## **Burlington Design Advisory Board**

### **DESIGN ADVISORY BOARD Tuesday, February 14, 2023 3:00 PM**

## MEMORANDUM

**To:** Design Advisory Board  
**From:** Scott Gustin & Garret King  
**Re:** 98 Sunset Cliff Road  
**Date:** February 14, 2023

L100

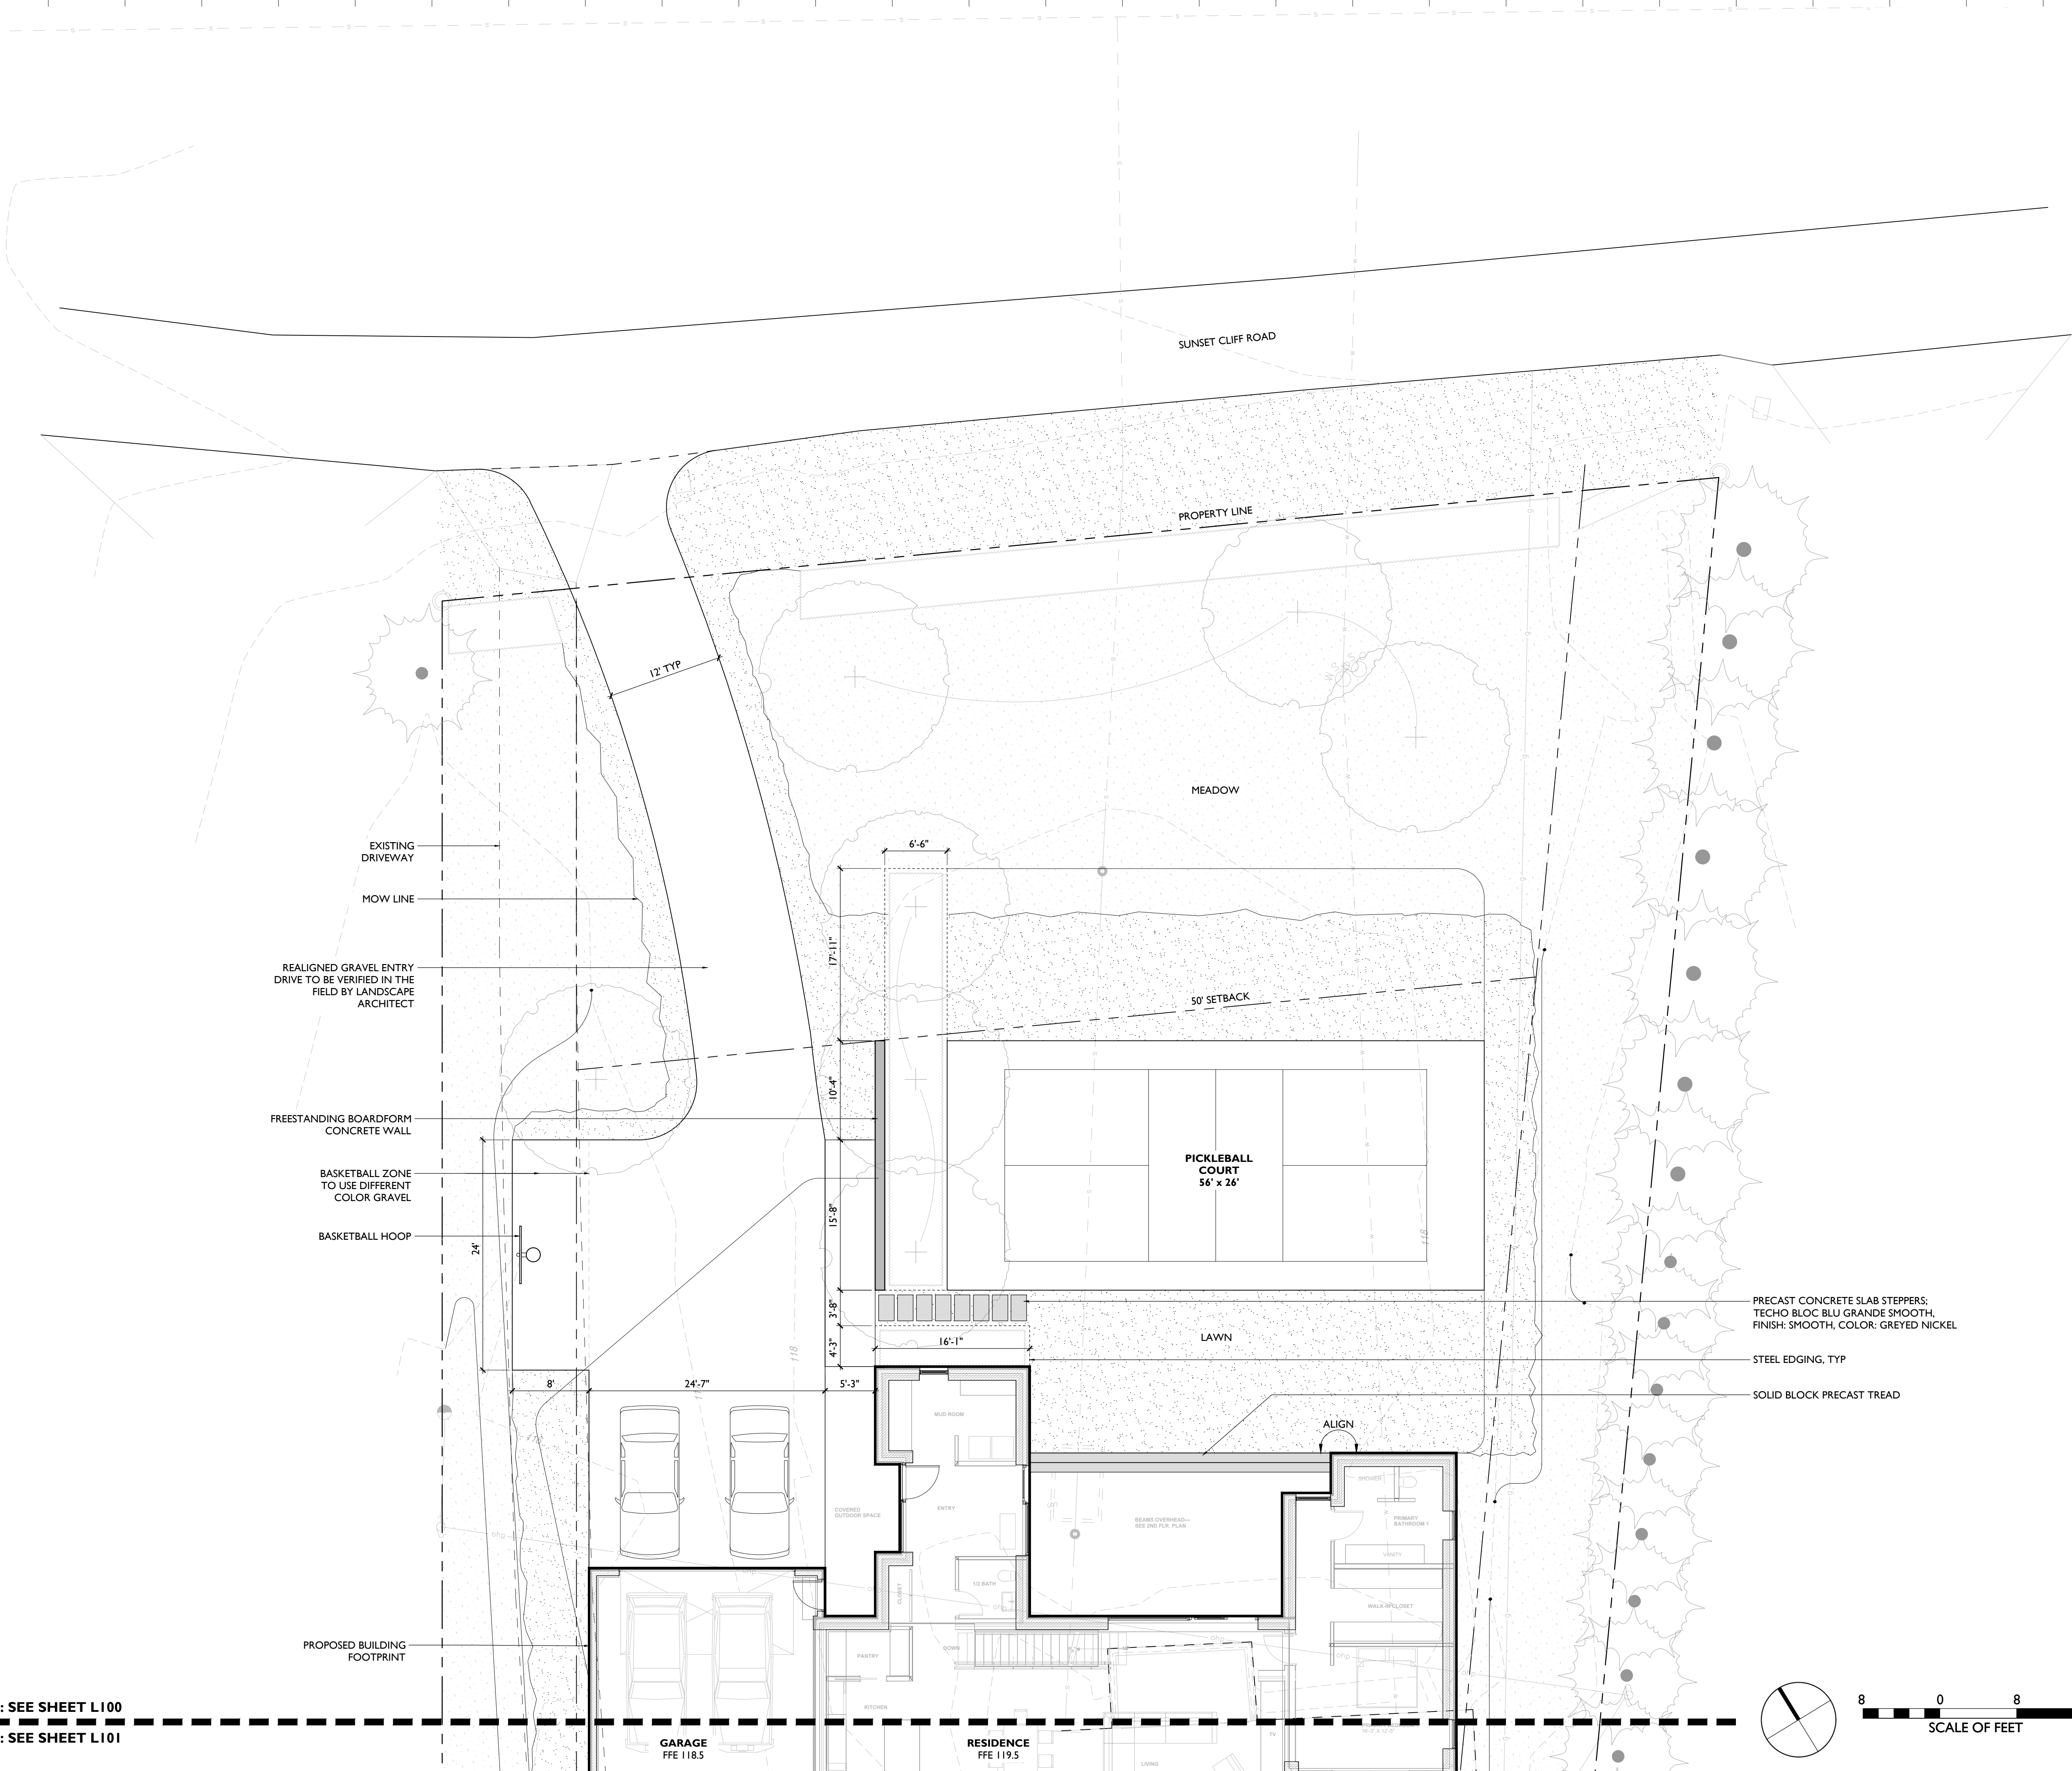
Residential driveways are generally limited to 18' in width but are allowed to widen as they approach the garage. Such is the case in this proposal. There is a turn-around that causes the driveway to reach ~ 32' width. This design is a recurring problem as to dimensional limitations and the front yard parking prohibition. Successful remedies have generally included a different material for the turn-around and a dual purpose (like patio or walkway) to distinguish it from the driveway. Revision is needed.

A complete landscaping plan has been provided and notes that most of the current trees will be retained. As noted above, a low-mow zone will be established along the property's lakeshore with additional shrubs planted to soften the edge with the existing seawall. The proposed landscaping plan depicts a variety of new plantings to accent the building and its front entrance. Some landscaping will provide screening. Proposed species are not invasive and appear to be acceptable.

1. Revised project plans addressing the following are needed:
  - a. Adjustment of the driveway and turn-around that limits the driveway to 18' (except where it approaches the garage) and differentiates the turn-around with a material different than that of the gravel driveway;
  - b. Utility lines shall be buried; and,
  - c. A perspective drawing should be provided.

# SITE PLAN FOR PERMIT

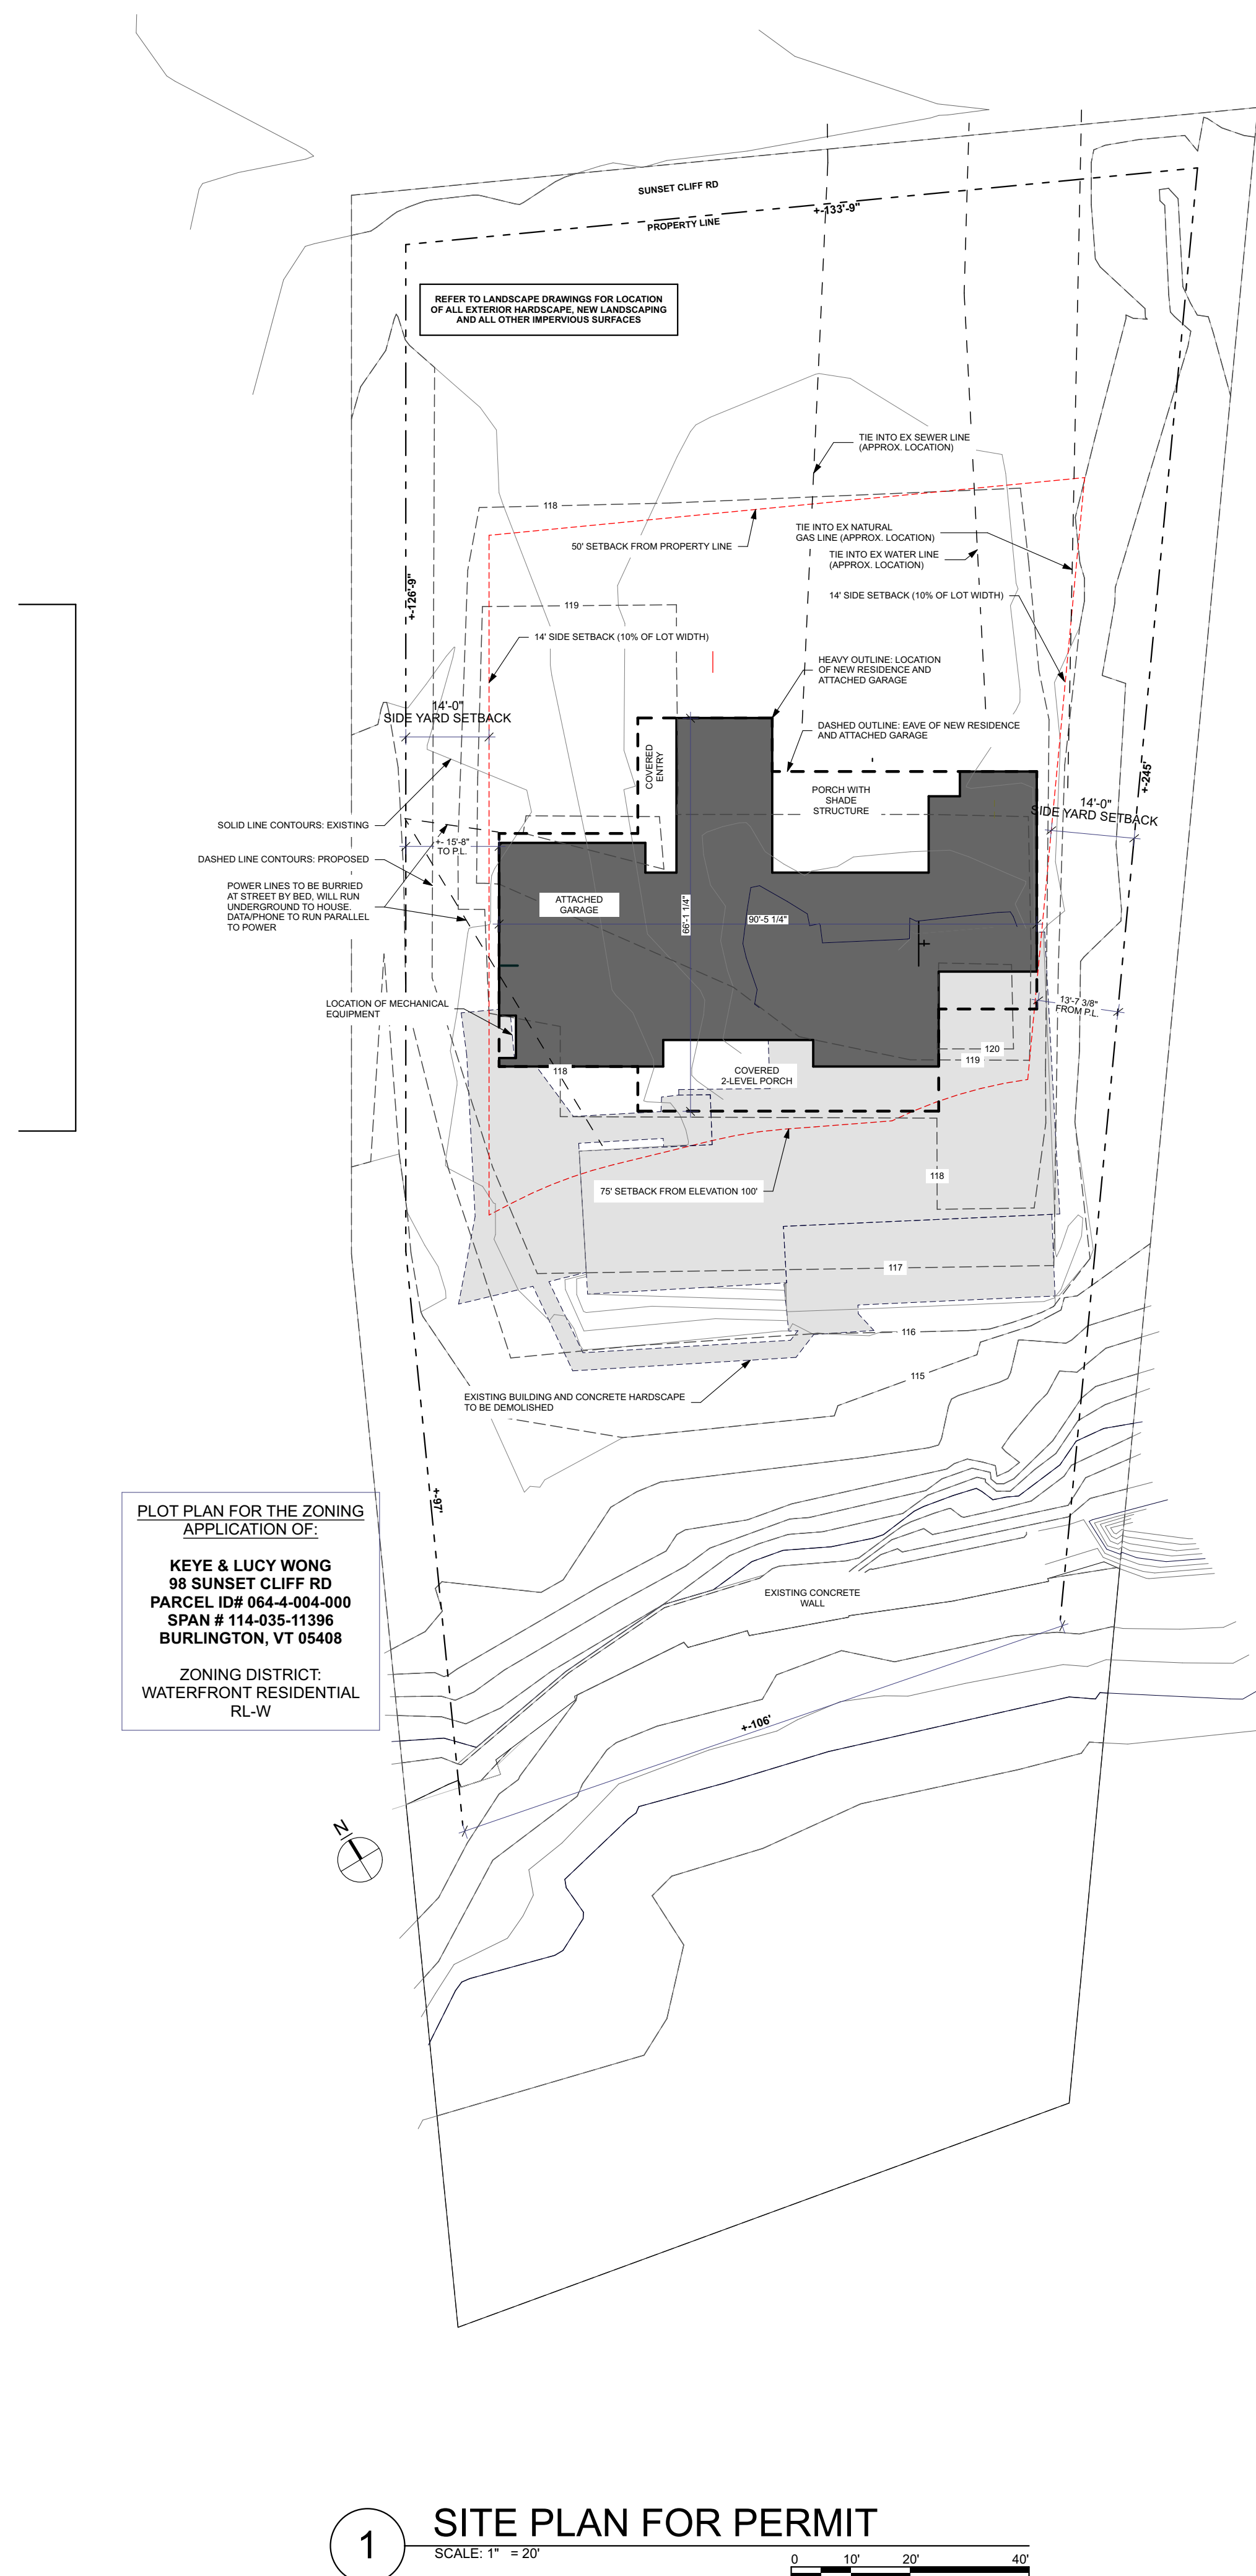
A preliminary water resources review has been done. An erosion prevention and sediment control plan is required and must be submitted for water resources review if not done so already. As proposed, stormwater runoff will be directed towards a bioretention area to the lakeside of the proposed home. Water resources review and approval of the final design is required.

Existing electric lines appear to be aboveground. This new construction will require buried electrical service. Utility connections to the house are shown on the plans as well as locations of

all applicable utility lines and pipes. Locations of mechanical equipment is noted and will be screend with material to match the siding of the house.
